**To:** Teri Camery (CBJ) **Date:** September 16, 2021  
**c:** Alix Pierce (CBJ) **Memo No.:** 3  
**From:** Rita Kors-Olthof, Vladislav Roujanski, Shirley McCuaig **File:** 704-ENG.EARC03168-01  
**Subject:** Responses to Public Comments Arising from Issued-for-Review Report (3<sup>rd</sup> Draft) and Landslide and Avalanche Hazard Public Meeting – July 21, 2021  
Downtown Juneau Landslide and Avalanche Assessment

This technical memo addresses some of the comments and questions that arose from Tetra Tech’s Issued-for-Review (3<sup>rd</sup> Draft) Report, Downtown Juneau Landslide and Avalanche Assessment, dated May 28, 2021, and the Landslide and Avalanche Hazard Public Meeting that took place on July 21, 2021.

**Figure 1:** Excerpts from CBJ’s 1987 adopted hazard mapping (left) and comparison of 1987 adopted hazard mapping and 2021 proposed hazard mapping (right) at the Starr Hill subdivision.

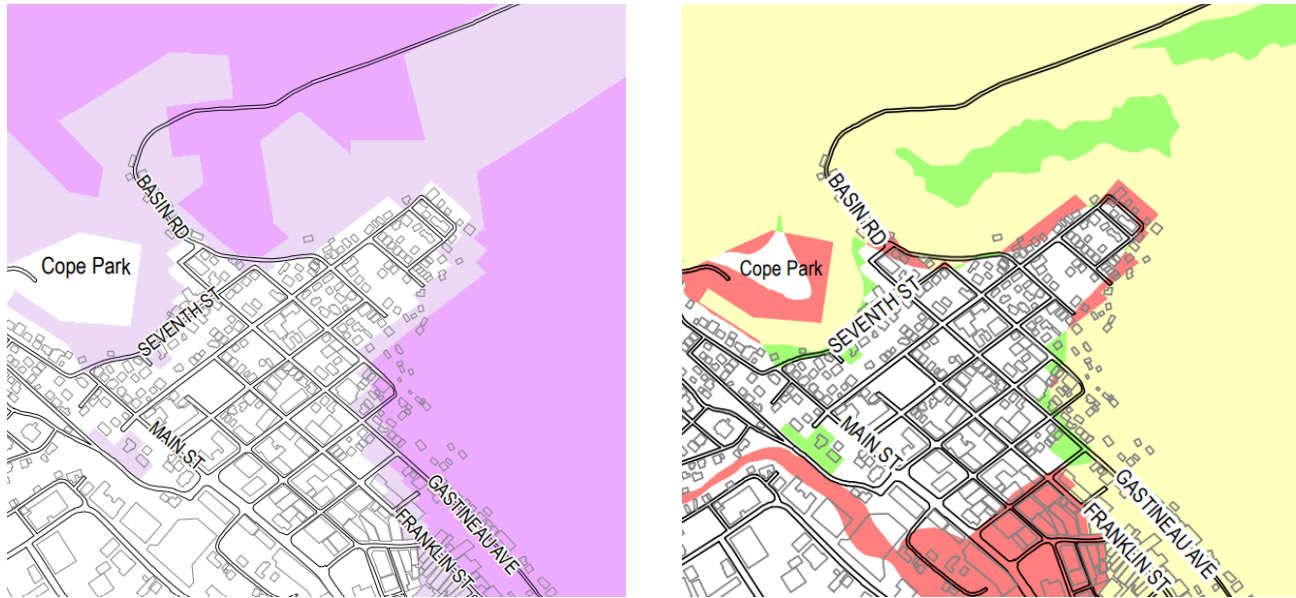
The residents of the Starr Hill Subdivision have been concerned to discover that landslide hazards designated High and Severe have been identified on the slopes around the subdivision. These hazards had not been identified in the 1987 adopted hazard mapping, in which only Moderate hazards had been shown at existing structures along most of the adjacent portion of Basin Road, 6<sup>th</sup> Street, Nelson Street, and several houses on 5<sup>th</sup> Street and in a zone upslope of 5<sup>th</sup> Street beyond the built roads of Kennedy and East Streets, as shown in Figure 1 below (left). Only a few structures further upslope of Kennedy, East, and Harris Streets were already mapped within a Severe zone in 1987, although continuing south and then southeast onto the main slope of Mt. Roberts, many more structures were mapped within Severe.

As seen in Figure 1 below, the main difference between the 1987 adopted hazard mapping and the new 2021 proposed hazard mapping is that many of the former Moderate areas surrounding Starr Hill (colored in pale lavender on the left) are now designated High or Severe (colored in dark pink on the right).

The 1987 adopted hazard mapping is understood to have been based on Swanston (1972). However, the 1987 mapping follows property lines, resulting in numerous right-angle corners in the hazard boundaries. The 2021 mapping does *not* follow property lines. It follows hazard designations based on terrain features, such as surficial geology, geomorphology (evidence of past and more recent slope movement types accentuated by vegetation patterns) and activity levels for slope instabilities as seen from the air photos and confirmed by field observations. For instance, along 6<sup>th</sup> Street, between East Street and Nelson Street, the lower boundary of the new 2021 proposed hazard zone does *not* arbitrarily stop at the upslope property lines of the affected properties as it does in the 1987 mapping. The same is true upslope of Nelson Street, and upslope of 5<sup>th</sup> Street, where the lower boundary of the 2021 proposed hazard mapping does *not* arbitrarily stop at the upslope property lines of the affected properties.

**Figure 3:** Excerpts from Tetra Tech Figure 1.3b Surficial Geology (left), and Figures 1.6c and 1.6h Landslide Hazard Designation Mapping (right).

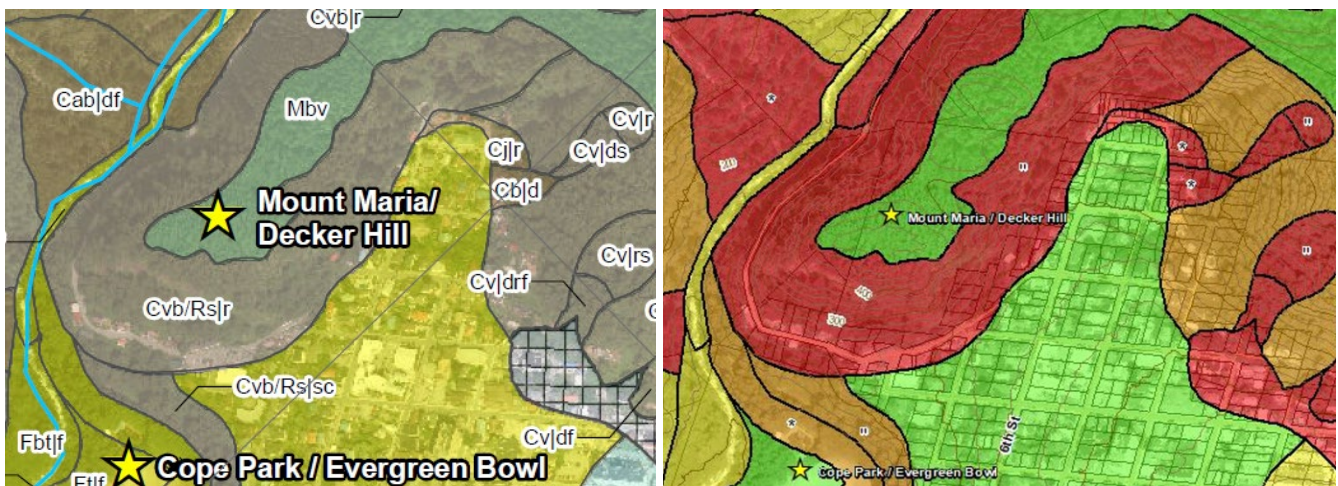
**Answer:** Upslope of Nelson Street, there are debris slides and rockfall. The hazard here varies from High to Severe, depending on location (Figure 4, right). The mudslides likely occur at areas of debris slides / flows shown on the surficial geology map (Figure 3, left), with some slide paths shown on Figures 11 and 14. Figure 9 shows some examples of active debris slide paths and rock bluffs above Nelson Street. See Question #3 for information on the effects of historical forestry activities on this slope and to see where the most prominent landslide paths are located. See Questions #5 and #6 for information on the slopes above the corner of Nelson and 5<sup>th</sup> Streets. See Question #12 for information on the possible effects of the old Mt. Roberts Trailhead.

Severe hazard designations are assigned to the areas subject to rockfall, debris slides, and debris flows, as shown on the surficial geology map in Figure 3 (left). Areas with a High hazard rating were assigned based on the results of the semi-quantitative analysis. These areas are expected to experience rockfall that damages but does not always knock out trees, and as such are a less severe hazard than a debris flow or debris slide that removes everything in its path. Evidence of this type of rockfall activity was identified during the field investigation.

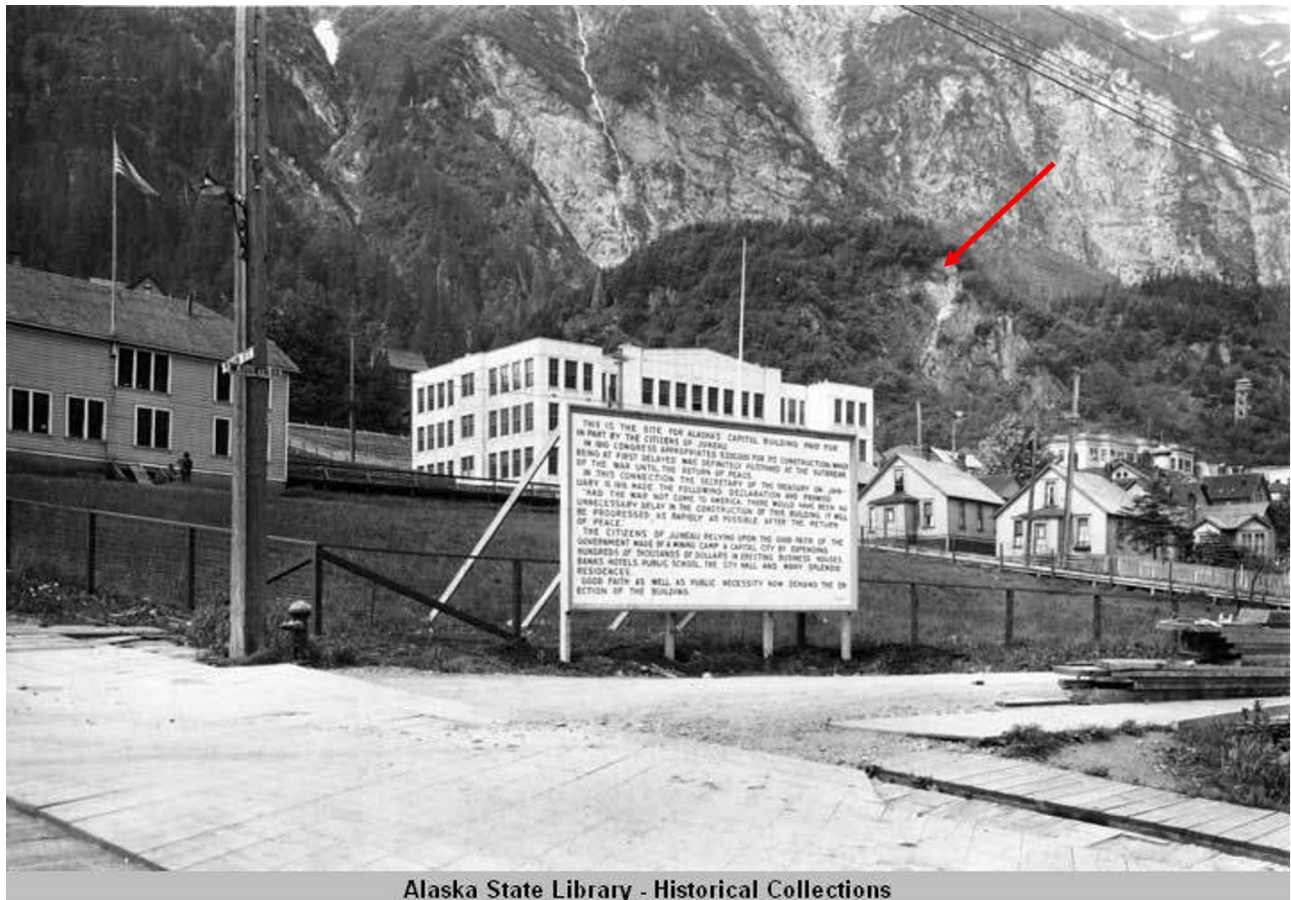
1. **Question/Comment:** I’ve seen the rockfall above Basin Road, and I can see why that slope is in a Severe hazard zone, but what about the slope above 6<sup>th</sup> Street? Why is that Severe?

The prehistoric slide area (Figure 5, blue arrow on left side) appears to be in the same place where a rockfall / rockslide was reported on October 18, 1913 (Swanston 1972, Figure 6), and where a distinct landslide scar is still present despite reforestation of the slope (Figure 13). Swanston reported that several houses had been destroyed, and that a deposit of angular rock fragments had been created above Basin Road between 6<sup>th</sup> and 7<sup>th</sup> Streets.

A news story about the 1913 event reported two large rocks, each several tons in weight, falling from the cliff on the side of Decker Hill facing town and above Basin Road (Figure 6). One of these rocks impacted a huge

boulder below, which had lain there for many years and, although the falling rock lifted the existing boulder up on edge, it was prevented from travelling further downslope. That existing boulder was reported to be located at the edge of the road, opposite the Nelson home, protecting it. The other large rock that fell was deflected and crossed the road to crush a woodshed below Basin Road, at the Price home. The power poles along Basin Road were also snapped, resulting in a short circuit (The Alaska Daily Empire, October 20, 1913). The Nelson home is likely Structure C-8 Nelson House II, located downslope of Basin Road at the northeast corner of Harris Street and Sixth Street (Juneau Inventory of Historic Sites, 1986). The Price home was not listed in the inventory, so its exact location is not known.

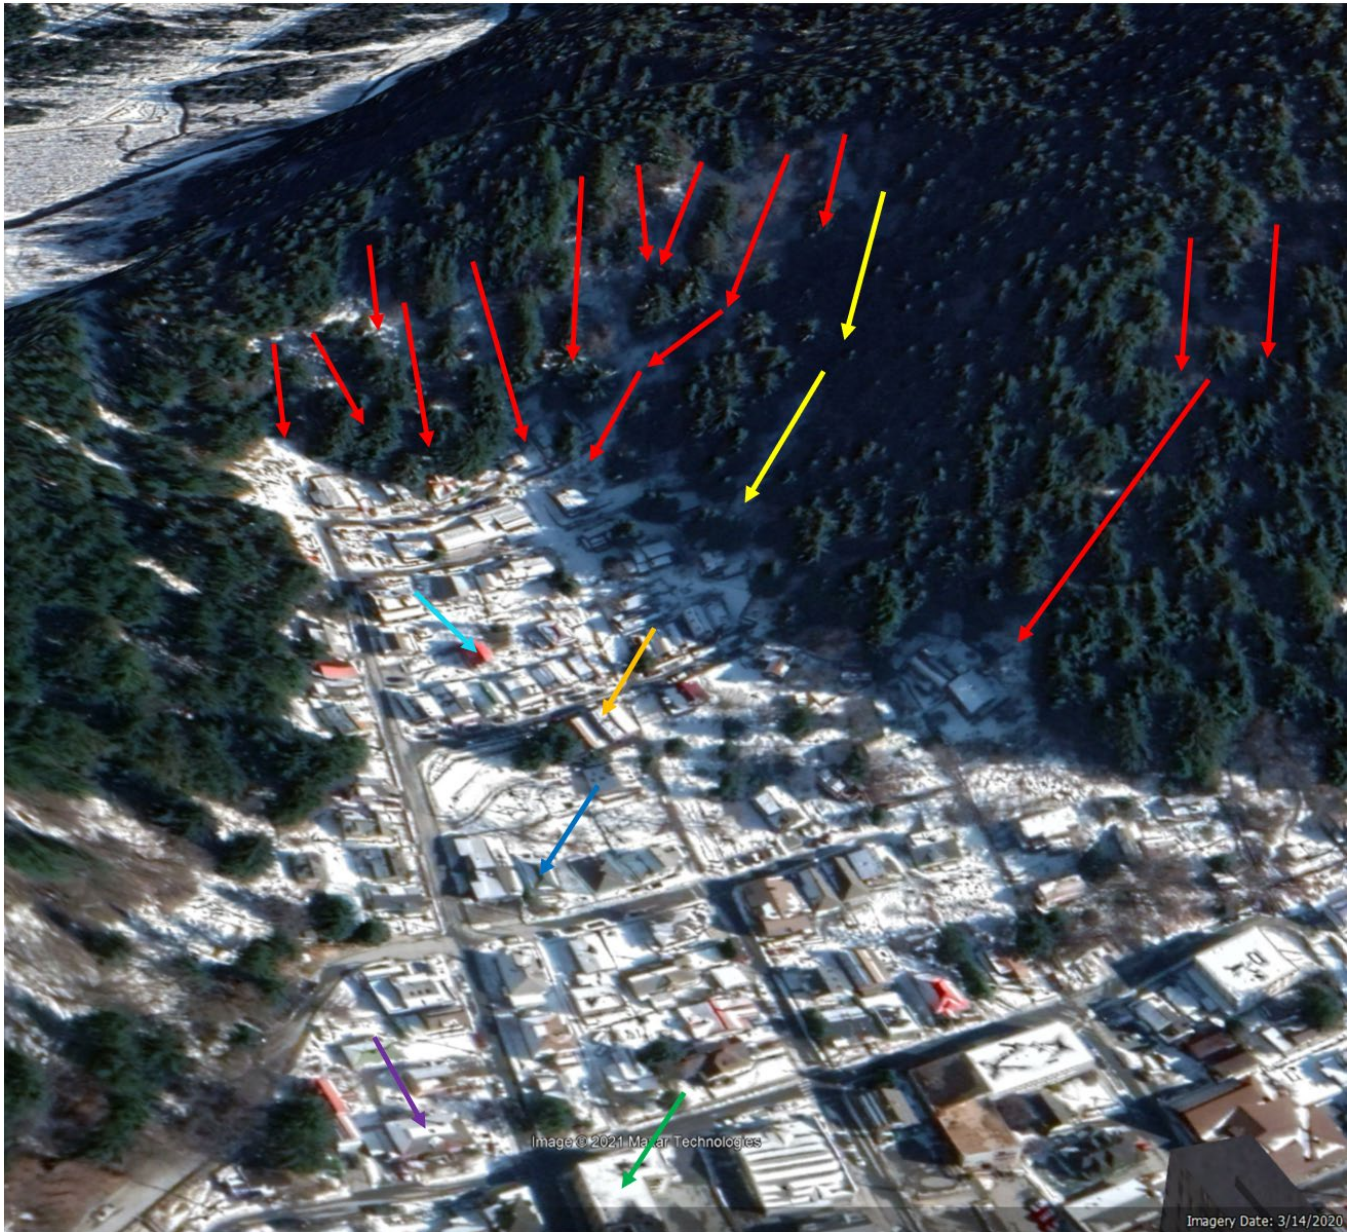
3. **Question/Comment:** Starr Hill / Mt. Maria were clearcut early on, and the area is gradually becoming reforested. These historical conditions would have exaggerated the landslide risks and frequencies during that time, while reforested conditions should reduce the risks, even with climate change-driven precipitation events. There was no discussion about that in the report.

In Figure 11, one of the main gullies (shown with two bright yellow arrows, ending between Park and Kennedy Streets) is the G000 Park debris flow gully. See Figure 14 for more information about this gully.

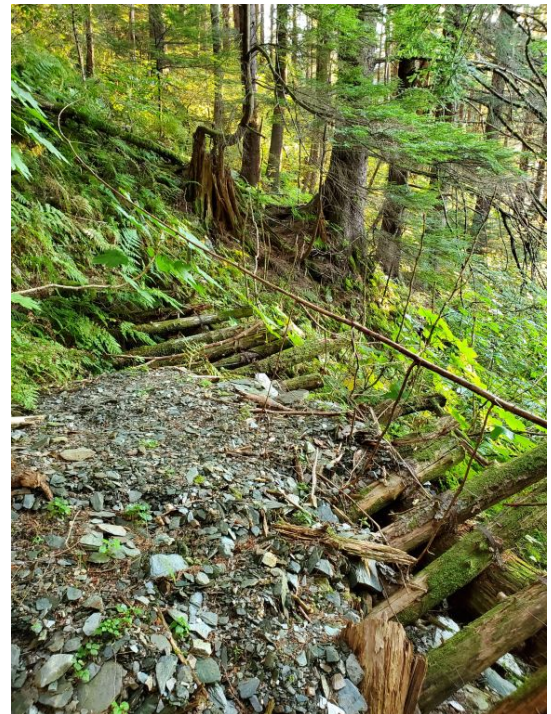
- 4. Question/Comment:** We agree that there is landslide activity in the [G000] Park gully, but properties have largely been protected by maintenance and instream mitigation structures and drains. The structures were installed by homeowners... with materials that were supplied by the City and Borough of Juneau. Some of these structures need to be repaired or replaced in order to continue proper drainage of this creek through the city-installed culvert that runs under the 725 Fifth Street home.

The area designated as Severe (red) has resulted in two debris flow events in the last 35 years... A debris flow incident occurred in the late 1980s, as a result of the drain above 725 5th Street becoming plugged because the home was vacant and there was no one to monitor/maintain the drain. In 2019, the gully creek undercut a bank, causing a flowerpot to fall and temporarily block the flow.

Although the residents have reported only two debris flow events in the past 35 years, this does not mean that the hazard is not significant. Based on the field observations, this debris flow gully has a high potential to affect downslope residences. Clearly, residents were concerned enough about the debris flow hazard to build structures to control debris flows, but these structures are not by any means engineered structures (Figure 15). Routing a debris-flow creek under a house also seems fraught, considering that the drain upslope has become plugged in the past, and that the slightest misstep upslope can create further havoc. (Case in point, the creek undercutting the stream bank and a fallen flowerpot blocking the flow in 2019.) Furthermore, as shown in Figure 14, it appears that this debris flow gully could potentially receive significantly more debris and water than just from the local slopes. As it stands, due to these multiple sources of hazard, Tetra Tech considers that this debris flow gully has been correctly designated as Severe.

Depending on the size of the next debris flow, the structure shown in Figure 15 could retain a little more debris or, instead, it could collapse, be overrun by debris, or even be completely scoured out by a larger debris flow that could originate from further up the gully. The same applies to the other structures documented by residents. Debris can incorporate both large and small woody debris, as seen in these photos and the photos supplied by residents of the mid- and upper reaches of the gully. The upslope portion of this debris flow feature is bowl-shaped, indicating the potential for small debris slides from the side slopes to fail and entrain debris in the gully, of which there is a significant amount. The particle size of the material that can be moved by a debris flow is also important – some cobble- and boulder-sized material is also visible in the residents’ photos. Despite the mitigation attempts, debris slides/flows could result in enough volume to impact the houses below.

**Figure 17:** Excerpt from the landslide hazard designation mapping. The purple outline shows an area where residents wanted more information to understand the shapes of the mapping units and the reasons supporting the hazard designations.

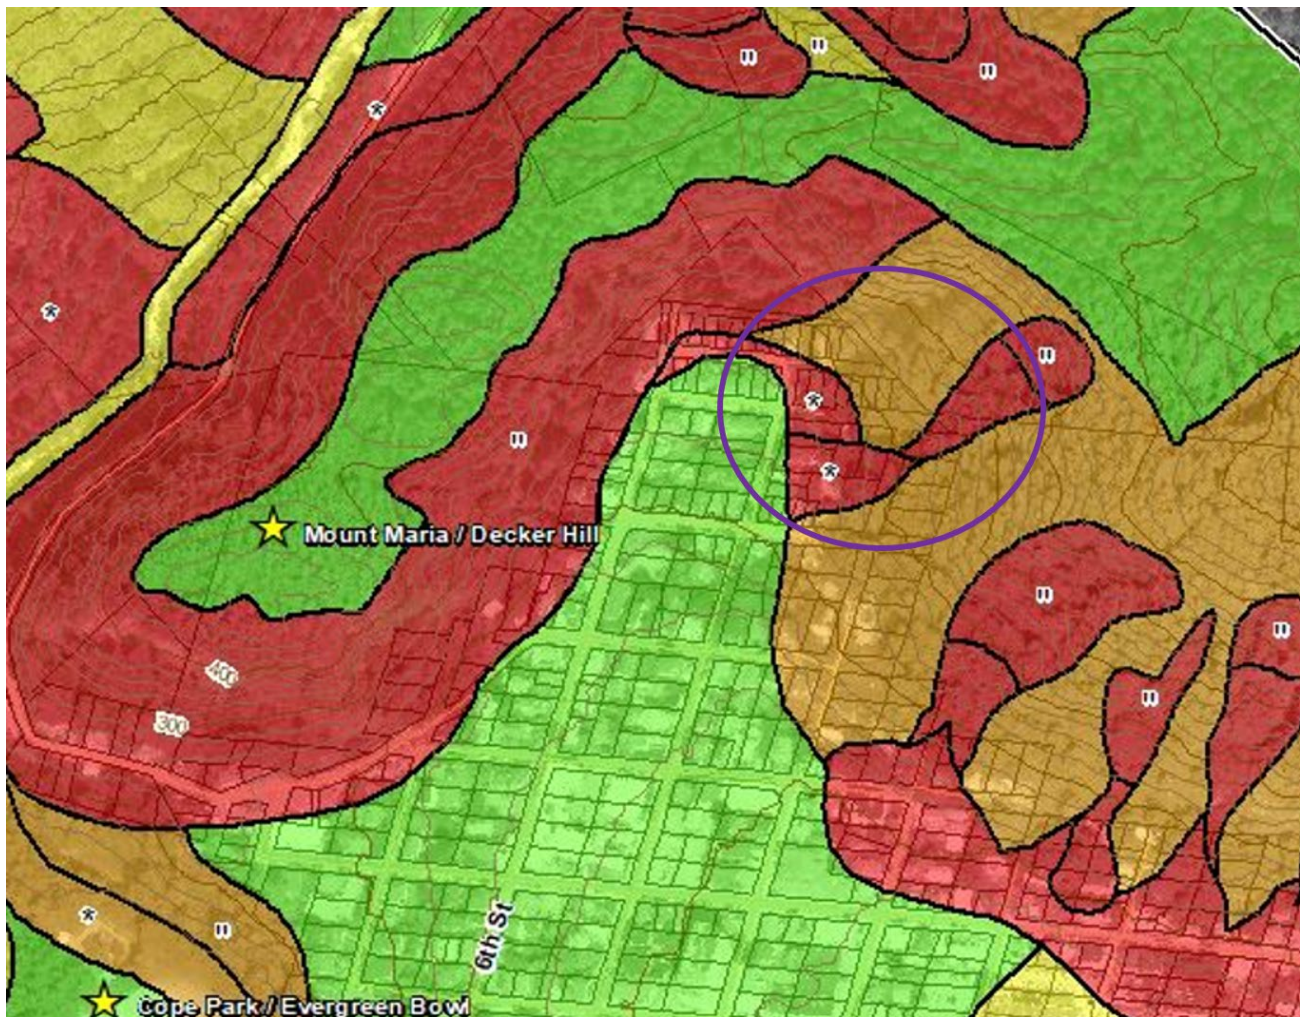
6. **Question/Comment:** The boundaries between the Low, Moderate, High and Severe landslide hazard zones do not seem to match the land.

**Answer:** The boundaries between the different landslide hazard designation zones are closely related to the surficial geology mapping terrain unit boundaries (Figure 3). The reason for this relationship is that the different soil and rock features have a large influence on how the slopes behave. If there is a shape that doesn't seem to make sense, it is helpful to look at the features beside that odd shape. Usually, it will be a terrain feature whose characteristics will govern the shape of the boundary between the two units, like a bedrock outcrop, or a terrain unit that overlaps a previous unit. Sometimes, the odd-looking boundary is only because there is a corner or curve in the slope, so that debris from one side falls down in one direction, and material from the other side falls down in a different direction. These two debris areas might then meet at the bottom of the slope. One example is at the southeast corner of the Starr Hill subdivision, where debris can fall or slide from above Nelson Street, and it can also fall or slide or flow from above 5<sup>th</sup> Street. Since this part of the subdivision is essentially the shape of a bowl, the mapping of the unit boundaries can also reflect slope contours and fall-lines, as well as the surficial geology unit boundaries. See also Technical Memo #2, Question #3, for more explanation on how apparently odd-shaped boundaries are determined.

Specific to this area of Starr Hill, it is now known that a resident has identified a recent landslide event in a High hazard zone (see Question #6 above), which also happens to be within one of the apparently odd-shaped hazard units (Figure 17, purple outline). This area will be reviewed to see if a shifting of the hazard boundary is warranted above Nelson Street. Note that the Severe hazard zone mapped at the toe of slope is due to this area being a deposition zone for slide debris.
